To: Members of Dublin City Council
From: Dana L. McDaniel, City Manager 
Date: January 5, 2017
Initiated By: Vincent A. Papsidero, FAICP, Planning Director
Jennifer M. Rauch, AICP, Planning Manager
Re: Basic Site Plan – Bridge Park West, Building Z2 – (Case#16-088ARB-BPR)

This is a request for review and approval of a Basic Plan Review for a mixed-use building including commercial and residential units with associated site improvements. The site is located east of North High Street, 180 feet north of the intersection with North Street. City Council is asked to review and make determinations on the Basic Plan applications in accordance with the amendments to the Bridge Street District (BSD) zoning regulations. Under these provisions, all projects involving development agreements require Basic Plan Review by City Council, who will then direct the review of the final Development Plan and Site Plan applications to City Council, the Planning and Zoning Commission, Architectural Review Board, or Administrative Review Team (as appropriate). This proposal for the Basic Plan Review includes seven Conditions and two Waivers.

2. BSD HTN – Bridge Street, Building Z2 16-088ARB-BPR 88 North Hi

SHEET
BSP8

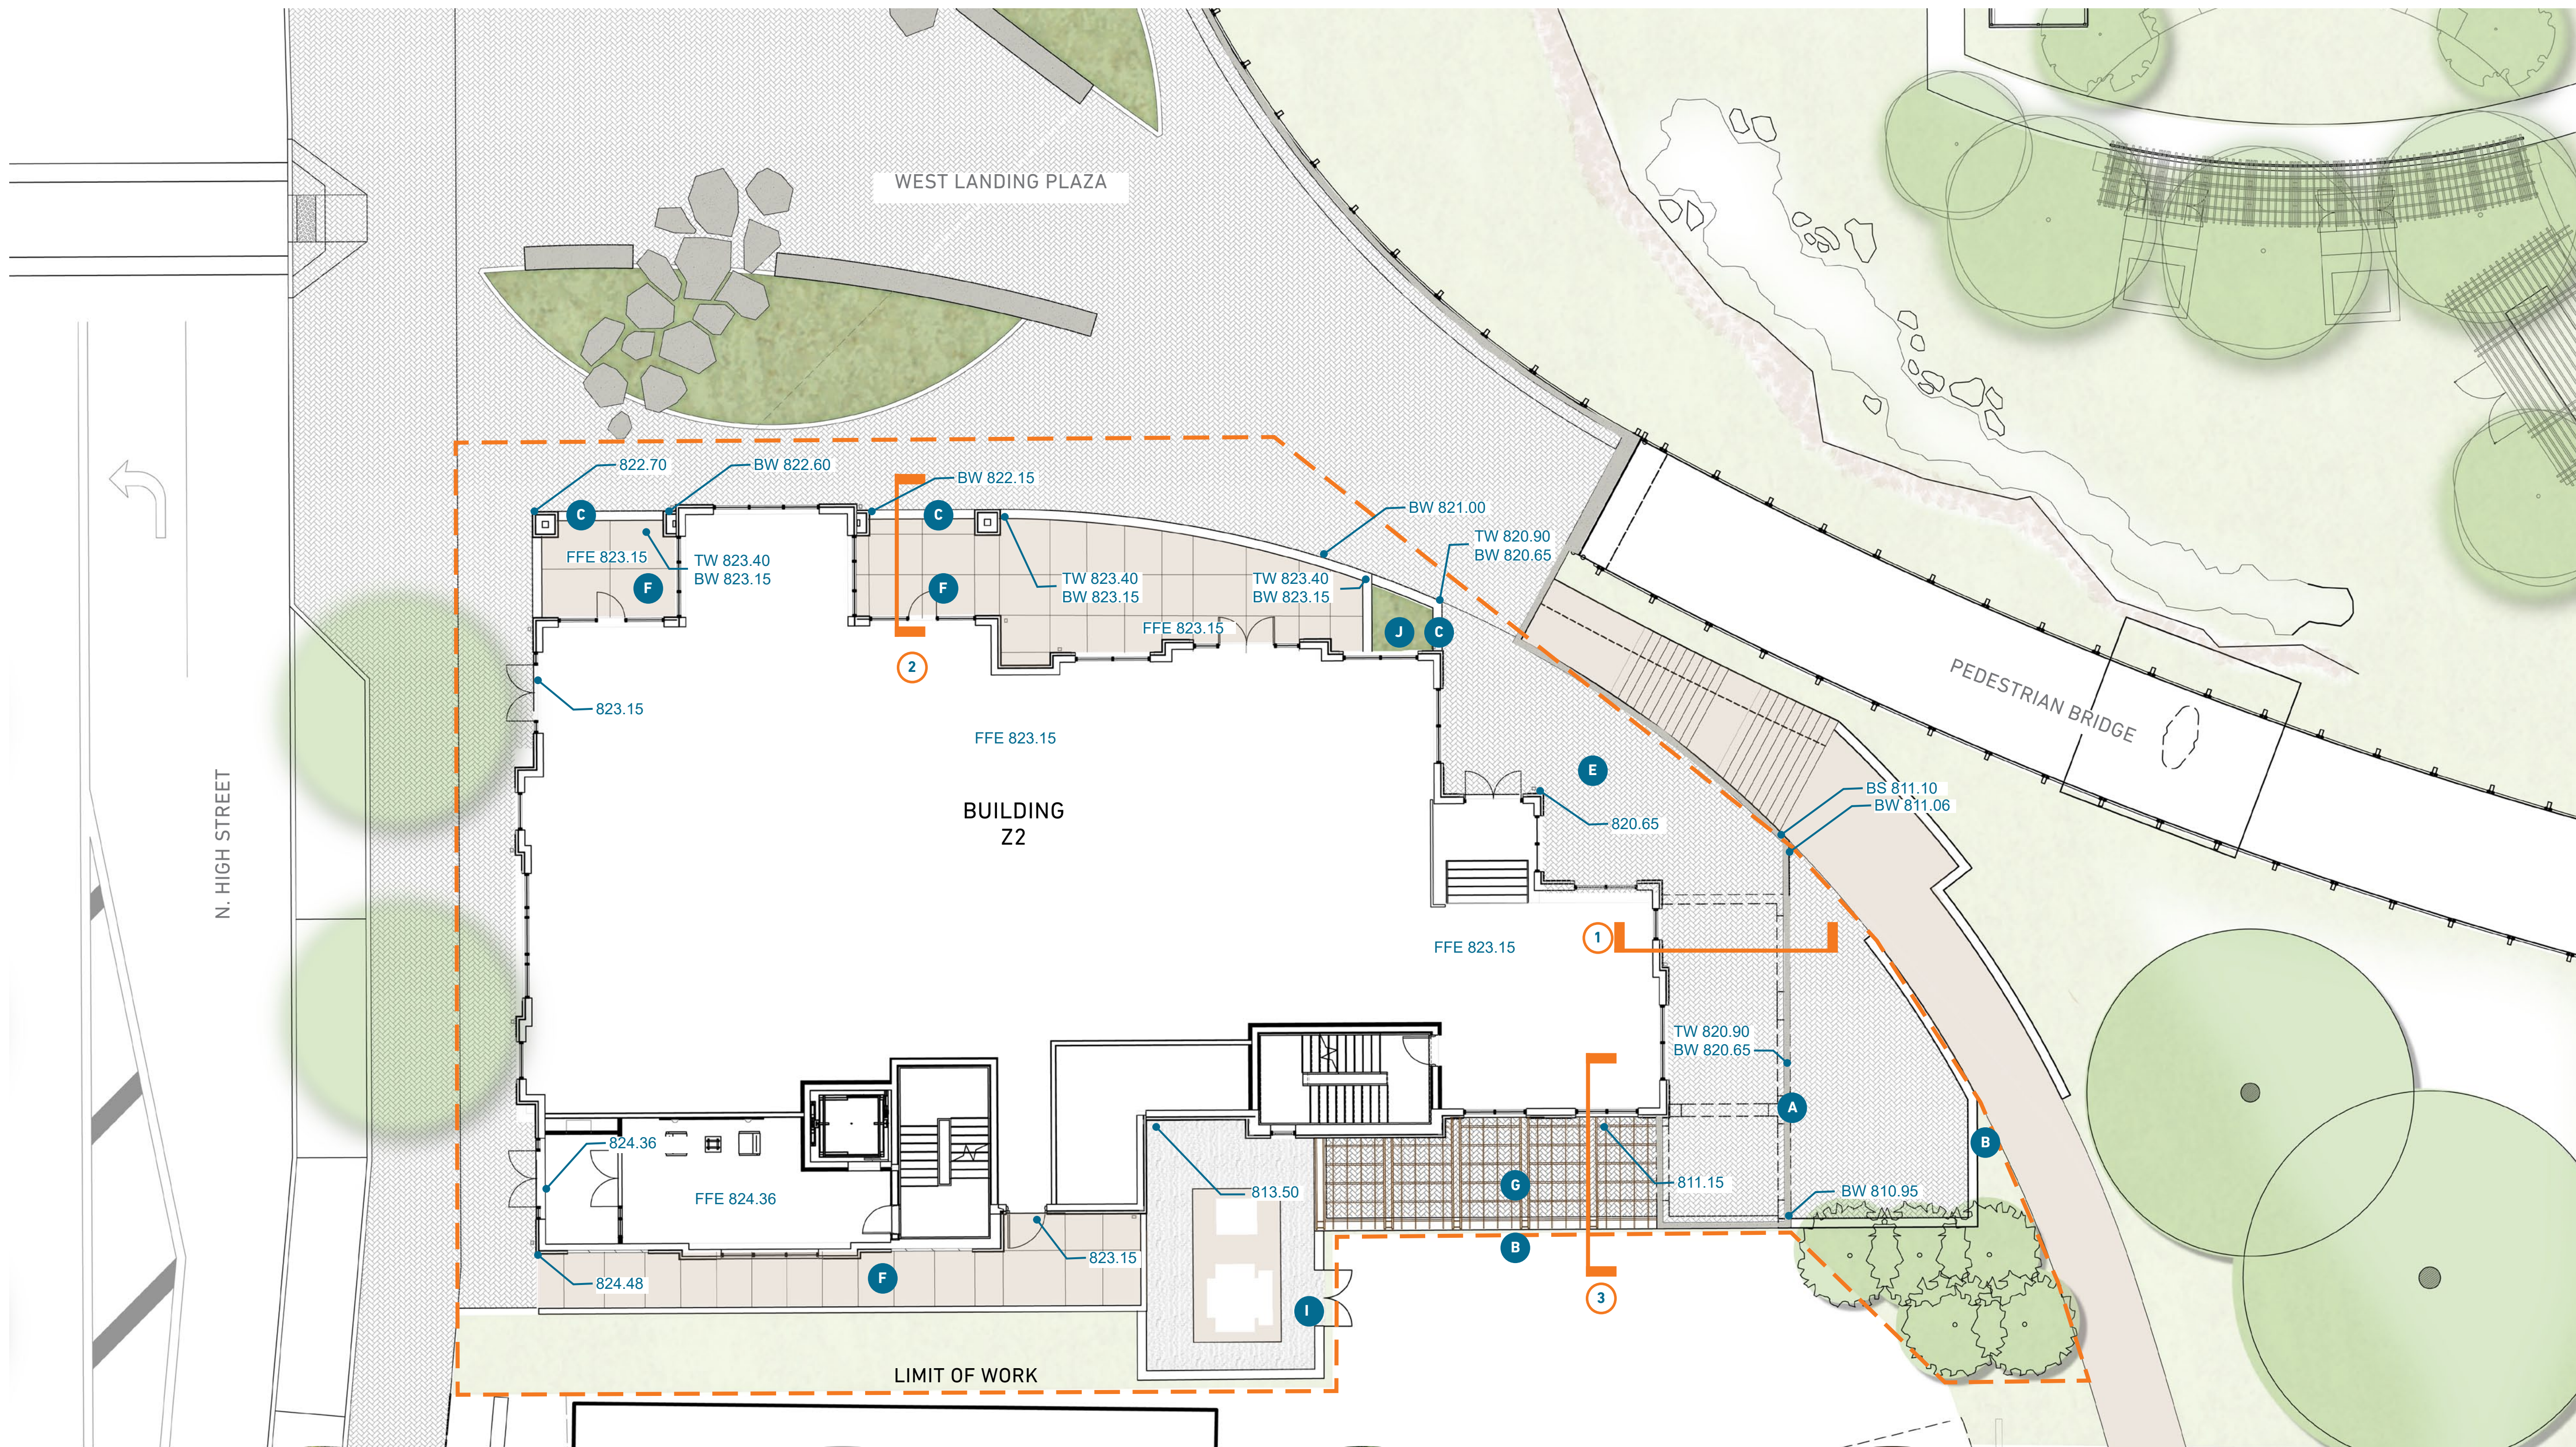
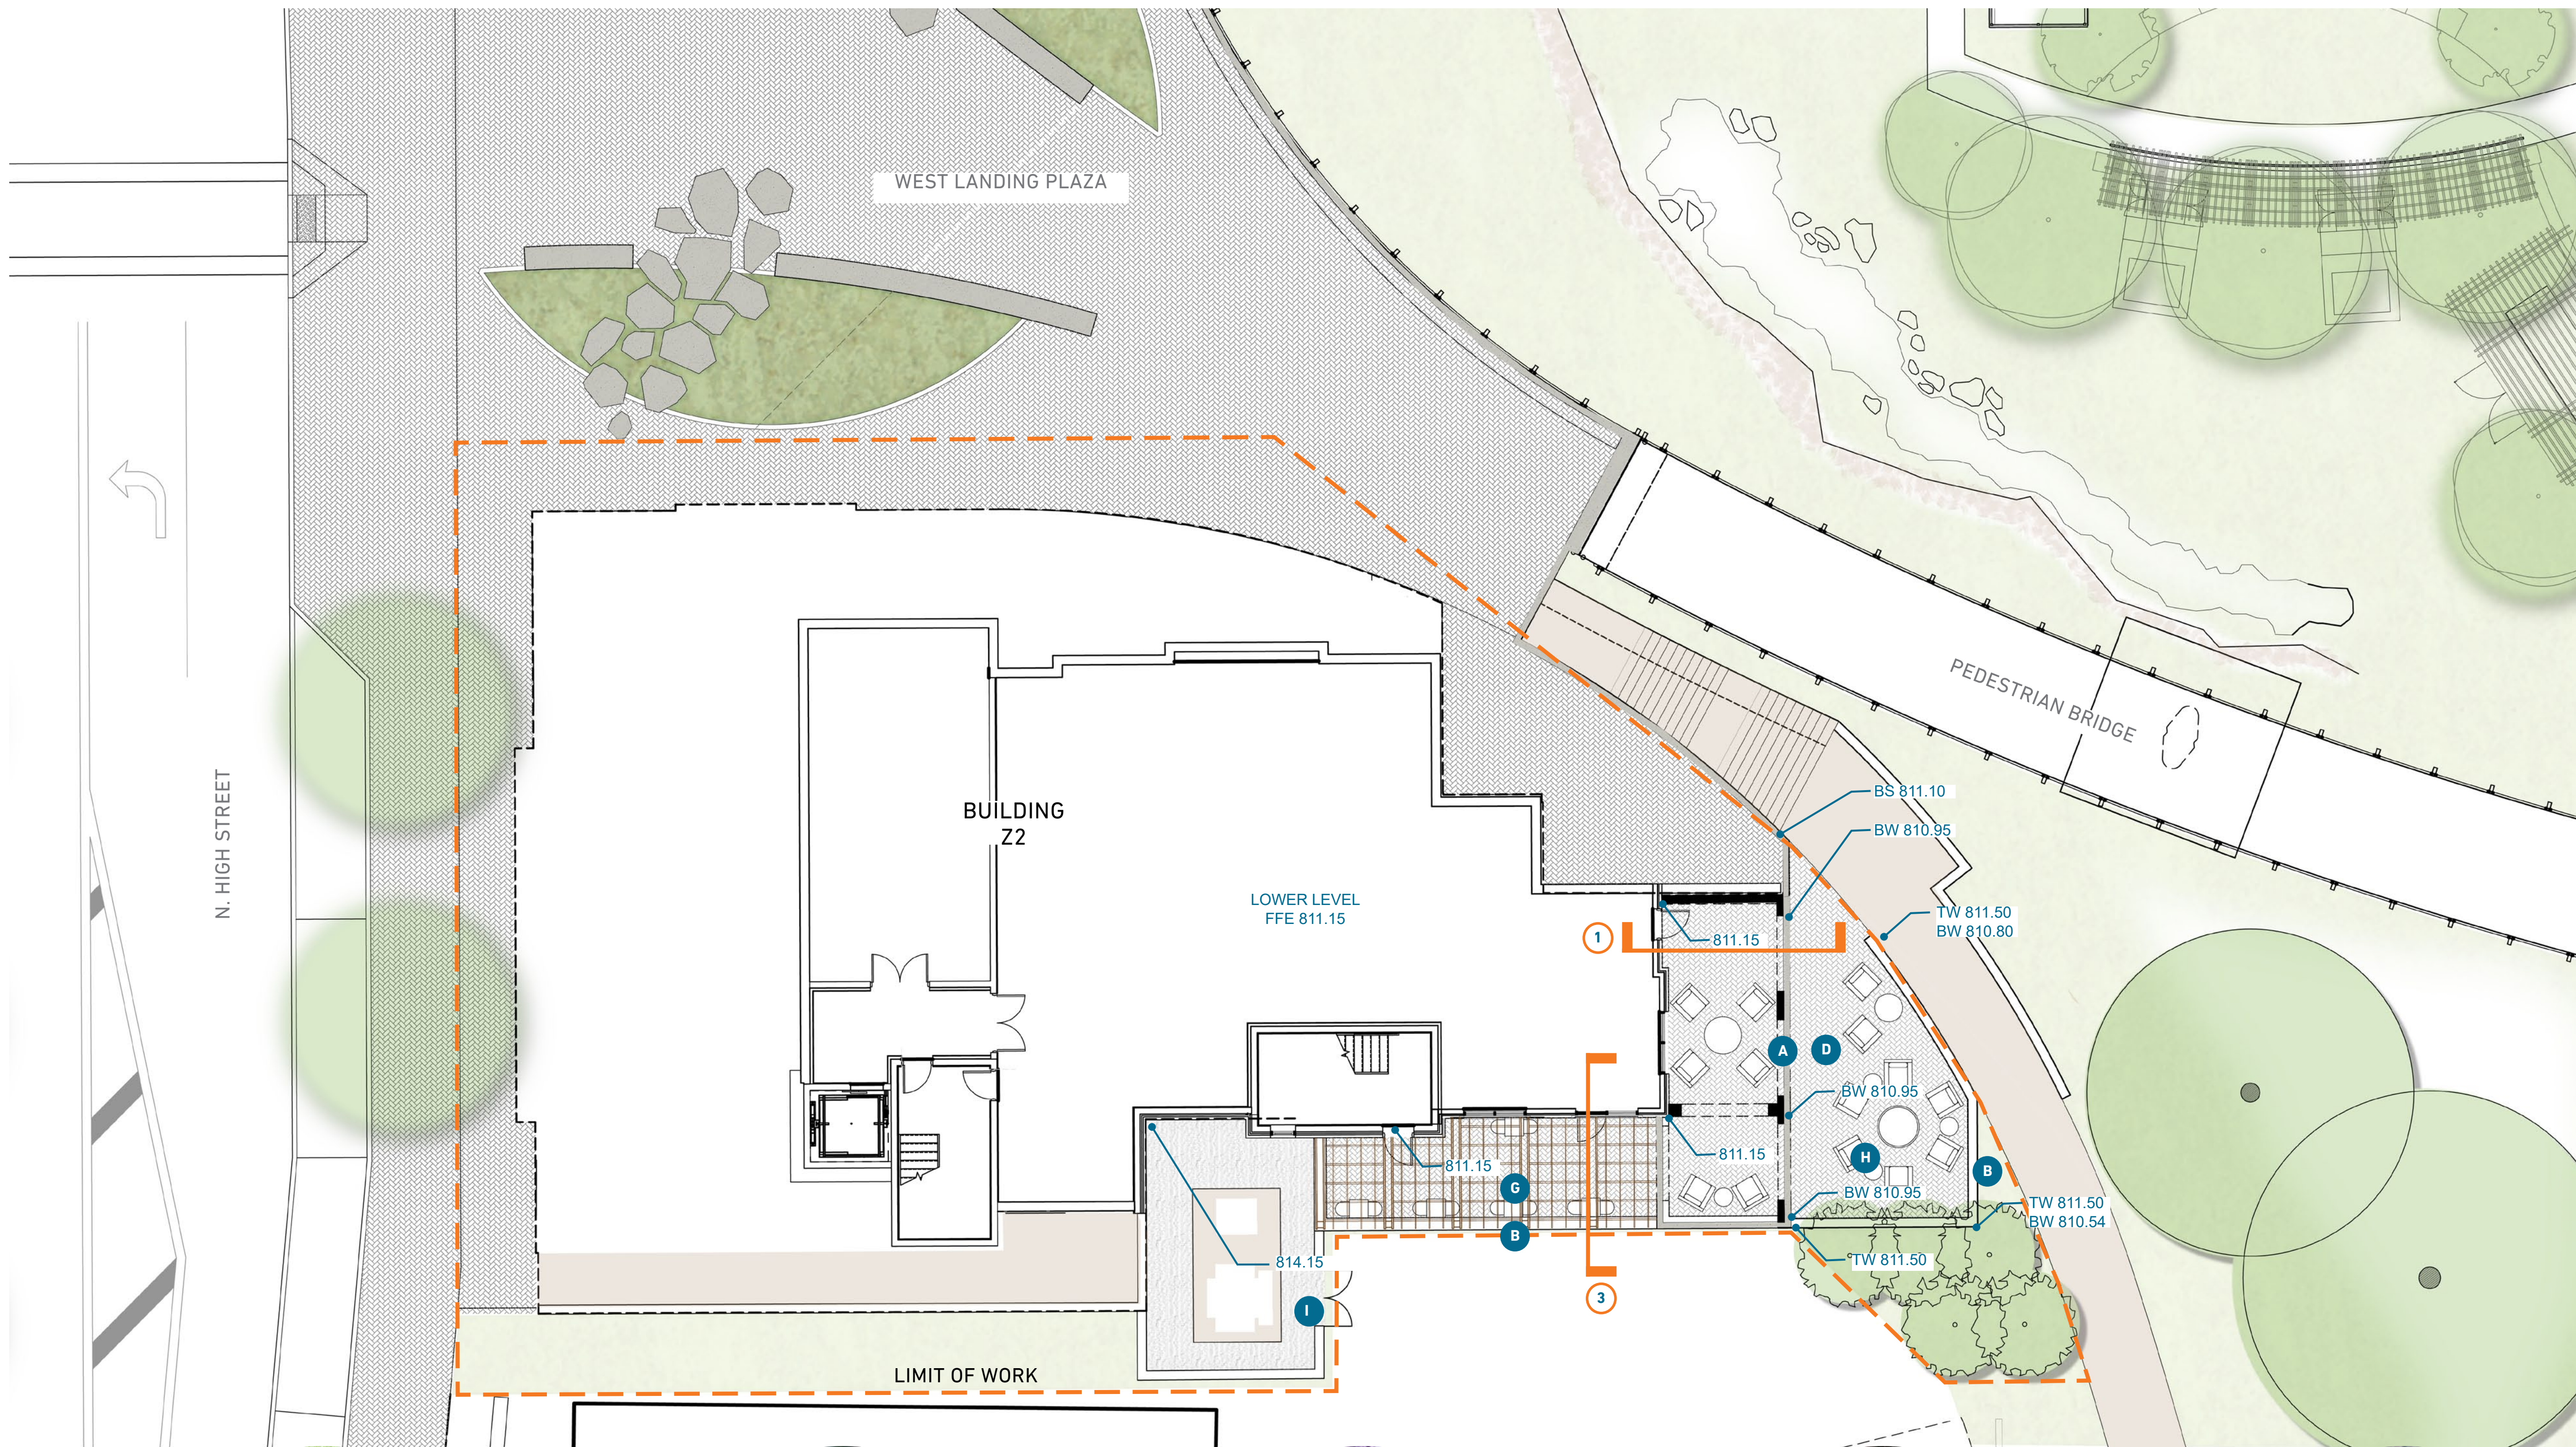
| Analysis | Basic Plan Review |
|--|---|
| Desirable Open Space | <i>Criteria met with conditions.</i> The open space, gateway and terminal vista details be addressed with the Site Plan. Final details regarding landscaping, lighting, utilities and stormwater will be provided with the Site Plan Review. |

| Code Section | Requirement | Notes | Met |
|--------------|---------------------------|---|----------------|
| (C)(2) | Provision of Open Space | There shall be a minimum of one square foot of publicly accessible open space for every 50 square feet of commercial space or fraction thereof and 200 square feet of open space per residential unit. Required open space shall be located within 660 feet of the main entrance to the commercial space as measured along a pedestrian walkway. <ul style="list-style-type: none"> There is a discrepancy in the Uses and square footage proposed in the Plans provided, therefore the precise amount of required open space cannot be calculated. Conservatively, ±0.023 acres (983 square feet) of open space is required and ±0.19 acres are provided. | Met/SPR |
